Subject: Response to 20 January 2006 Agency Comments on the Final
Perimeter Groundwater Operable Unit Remedial
Investigation/Feasibility Study

Below are ERM-West, Inc. (ERM) and Aerojet's responses to the most-recently received Agency comments on the Final Perimeter Groundwater Operable Unit Remedial Investigation/Feasibility Study (PGOU RI/FS Report) provided by the United States Environmental Protection Agency (USEPA) in a letter dated 20 January 2006. The text of each comment is repeated verbatim in bold italics, followed by ERM/Aerojet's response.

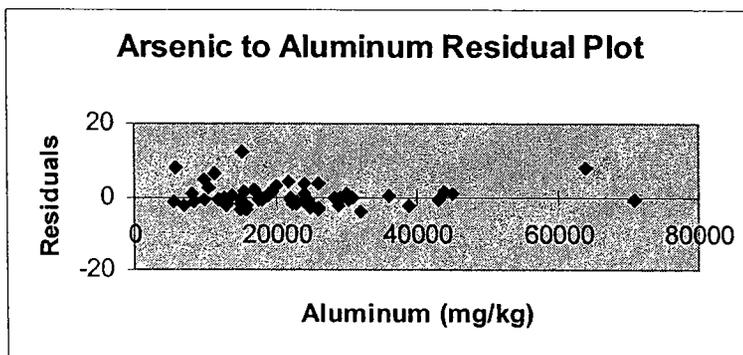
- 3) *"X Variable 1 Residual Plot and Spearman Rank Correlation"*
The Residual Plot provided in Aerojet's response, as well as the Spearman Rank Correlation (SRC) rationale, is inadequate as presented to support any comment responses. Aerojet needs to provide the following:

- *Labels, units, and related variables for the Residual Plot.*
 - o *Ensure that the scaling of the residuals axis is such that visual evaluation of the data distribution is possible; the Residuals axis scale should be symmetrical around the zero-point (i.e., -20 to +20, etc.).*

- *Generate a Residual Plot for log-transformed data (if appropriate). Evaluate the distribution of residuals for transformed data.*
 - *Provide the values of the variables determined for any statistical calculations (e.g., SRC), and include other constants (e.g., number of data points, number of non-detects, etc.).*

As previously noted, the arsenic to aluminum residual plot is merely illustrative of the deviation of the data from normality, which is also evident from the analysis conducted for the comparison of the PGOU data with the background data set as presented in the RI/FS report. The arsenic to aluminum Spearman Rank Correlation statistic, SRC is 0.49 ($p < 0.001$), $n = 108$. This is a nonparametric correlation statistic and is independent of the data distribution. Other relevant statistics are provided in the RI/FS report and appendices. A revised residual plot is provided, as follows.
